Waco LE- ADA Evaluation

Report Date: 01/15/2024

LE- Waco TX, ADA Evaluation

Accessibility Evaluation

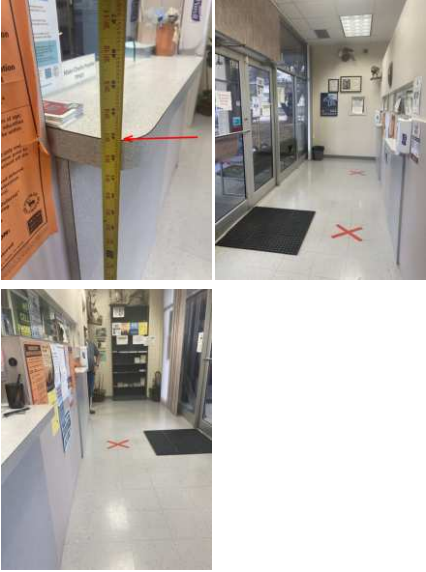
5	Exterior of Property (Public): Path of Travel to Building - Curb Ramp (Main Route)	The curb ramp exceeds the maximum running slope (parallel to the direction of travel) allowable of 8.33%. Curb ramps should have the least possible slope but in no case more than 8.33% (1:12).	Running slope is 10.2%	https://www.access-board.gov/ada/#ada-406_1 https://www.access-board.gov/ada/#ada-405_2	2012 TAS Section: 406.1 2010 ADAS Section: 406.1 2015 ABAAS Section: 406.1
